REMARKS

Applicant hereby responds to the Office Action of Jan. 18, 2005, in the above-referenced patent application. Before this Amendment, Claims 1-20 were pending in the above-referenced patent application. Through this Amendment, Claims 21-32 have been added, such that Claims 1-32 are now pending in the patent application. No new matter has been added.

Drawings

Figure 3

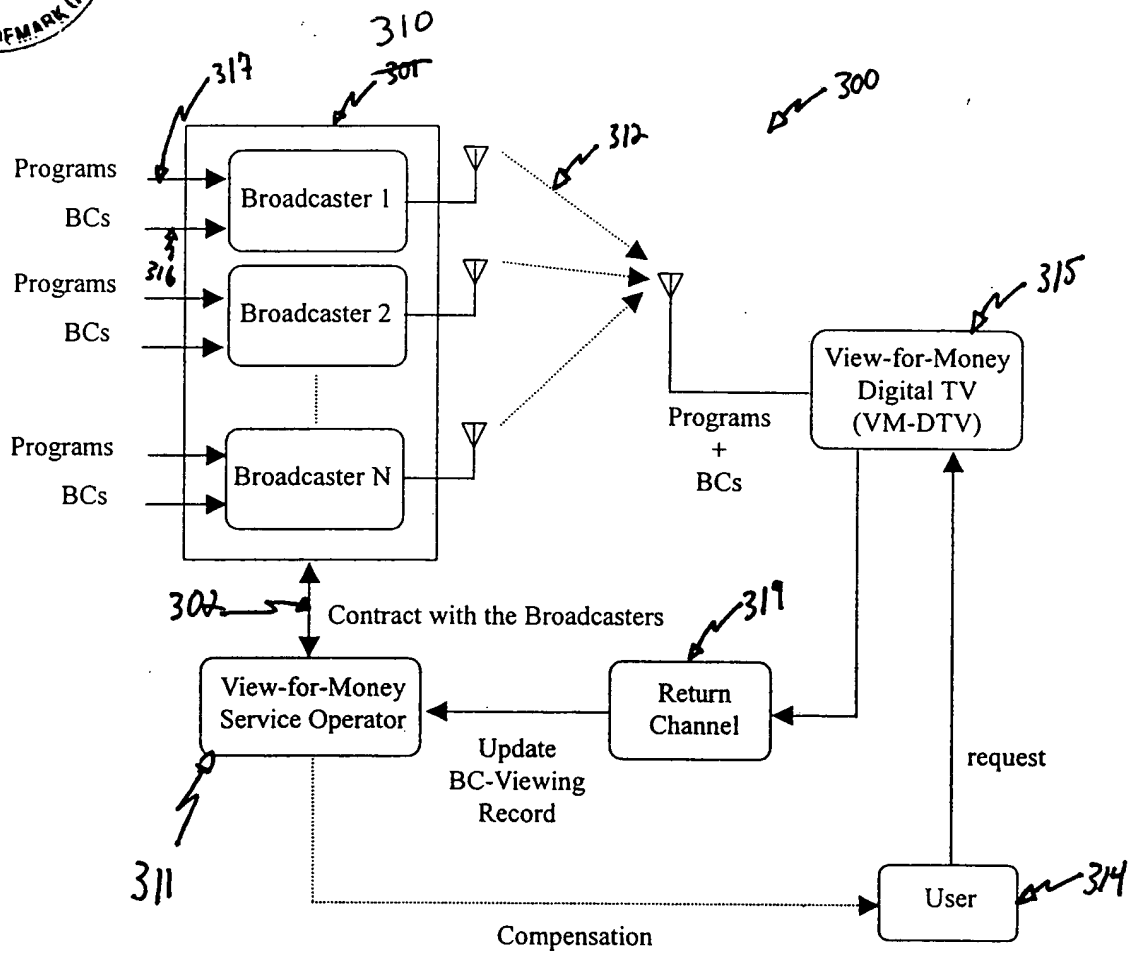
In Fig. 3, reference character "301" has been corrected to "310". In Fig. 4, reference character "429" has been added, reference character "417" has been added and reference character "430" has been corrected. In Fig. 8, reference character "800" has been added.
